**SUSQUEHANNA STEAM ELECTRIC STATION
PROPOSED AMENDMENT NO. 318 TO UNIT 1
FACILITY OPERATING LICENSE NPF-14 AND
PROPOSED AMENDMENT NO. 290 TO UNIT 2
FACILITY OPERATING LICENSE NPF-22: REVISE
TECHNICAL SPECIFICATION 3.4.10 "RCS PRESSURE
AND TEMPERATURE (P/T) LIMITS"
PLA-7181**

**Docket Nos. 50-387
and 50-388**

**PROPOSED TECHNICAL SPECIFICATION
CHANGE
(MARKUPS)**

Minimum Reactor Vessel Metal Temperature (degrees F)
FIGURE 3.4.10-1
System Hydrotest Limit with Fuel in Vessel for 35.7 EFPY
(Curve A)

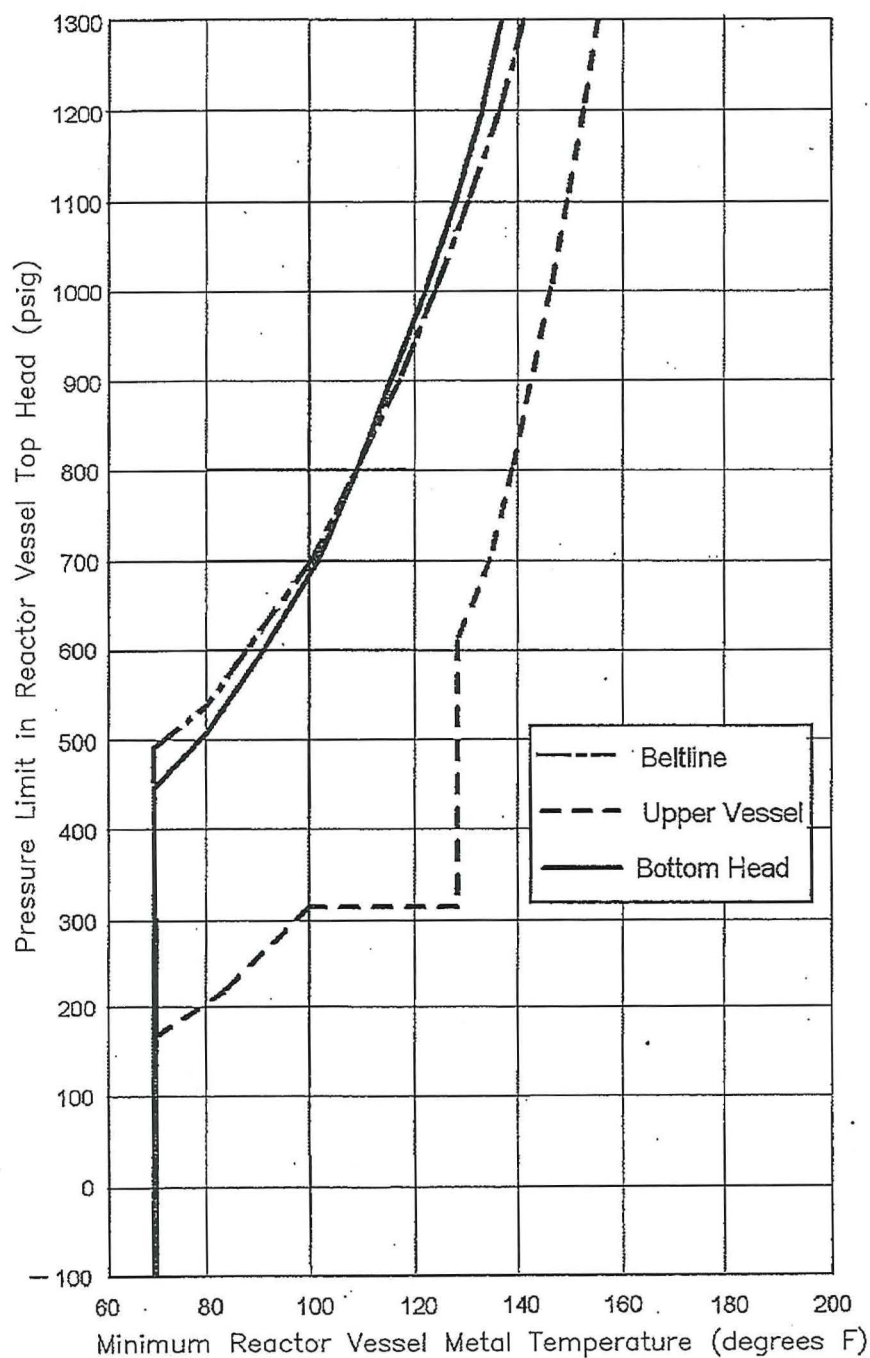
The proposed changes are to TS Figures 3.4.10-1, 3.4.10-2, and 3.4.10-3, which show the P/T Limits curves for in-service leakage and hydrostatic testing, non-nuclear heatup and cooldown, and criticality, respectively.

The proposed P/T Limits curves are valid for 35.7 EFPY for SSES Unit 1 and 30.2 EFPY for SSES Unit 2. The plotted values of the proposed curves at and above the 0 psig value for the reactor vessel top head pressure are identical to the plotted values on the present curves contained in NRC-approved amendments 232 and 209 for Unit 1 and Unit 2, respectively (Reference 7.1). The proposed change for each P/T Limits curve is to extend the curve below 0 psig to define the minimum reactor vessel metal temperature at a reactor vessel tophead pressure below 0 psig is 70 degrees F.

The proposed changes revise TS Section 3.4.10, "RCS Pressure and Temperature (P/T) Limits," by adding a clarification on each of the P/T Limits curves to allow operation at an RPV pressure of less than 0 psig.
